SERVICE BULLETIN BOOK

SCHWING SERVICE DEPARTMENT

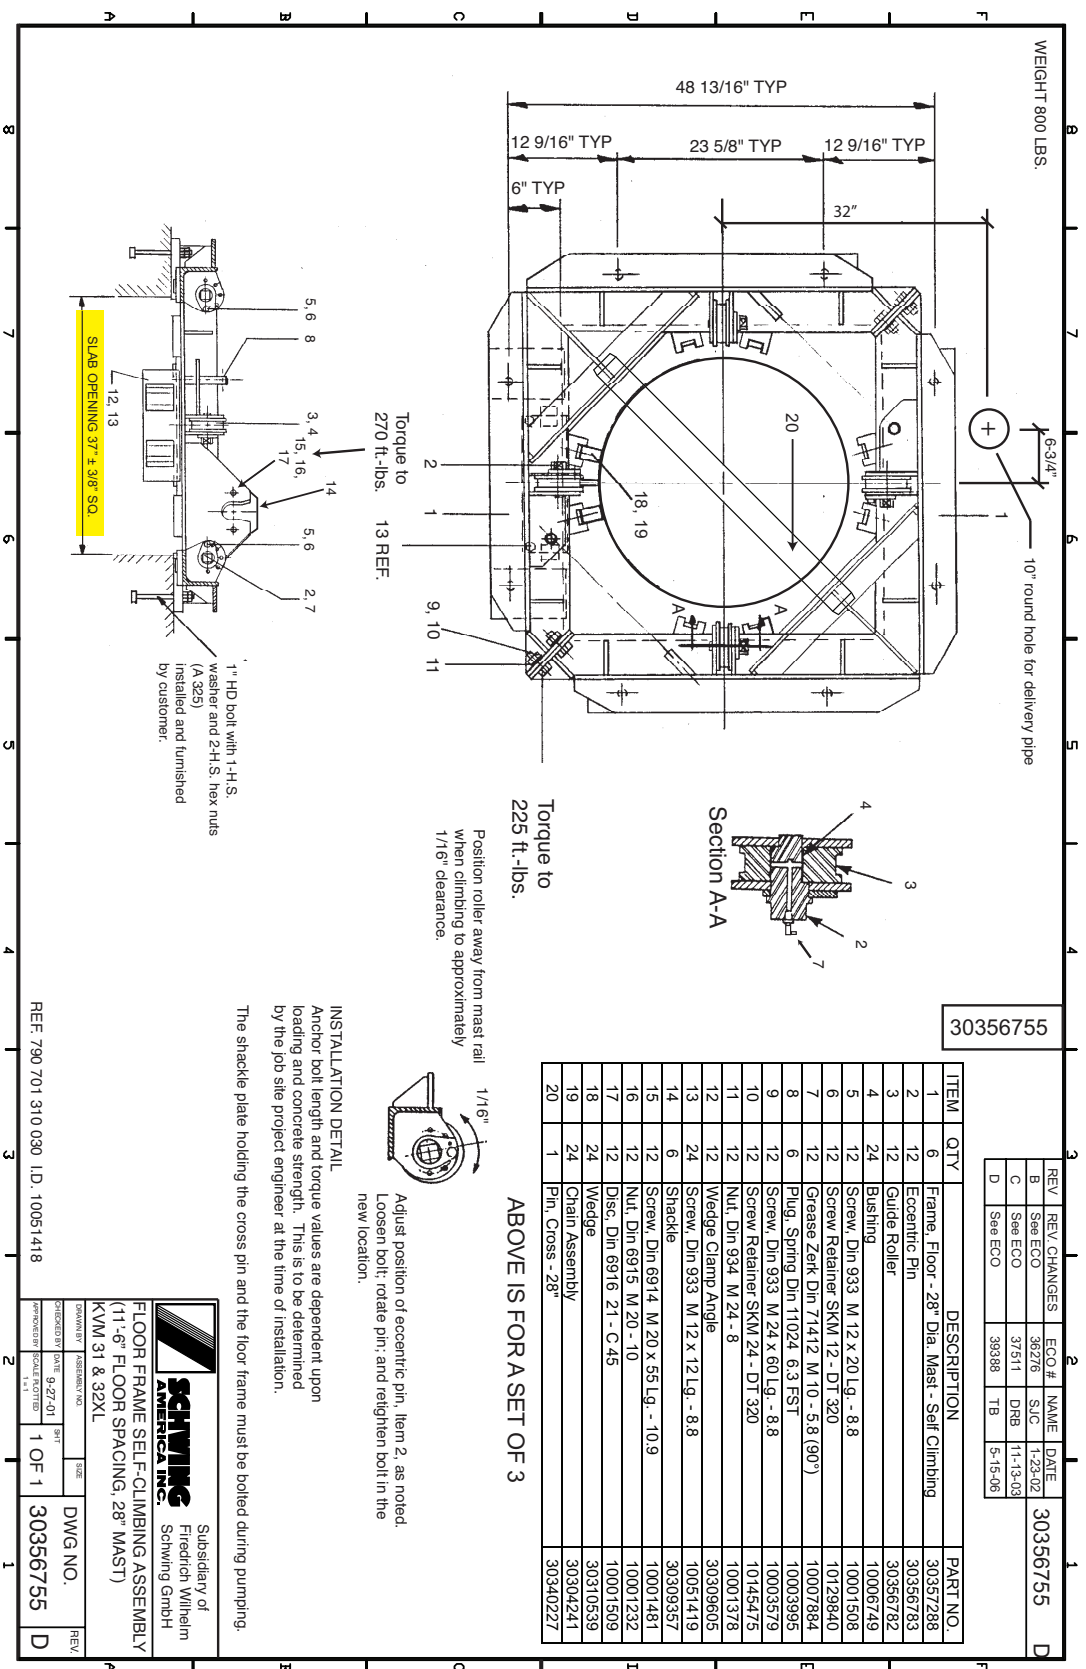
Adjust position of eccentric pin, Item 2, as noted. Loosen bolt; rotate pin; and retighten bolt in the new location.

Torque to 225 ft.-lbs. Position roller away from mast rail when climbing to approximately 1/16" clearance.
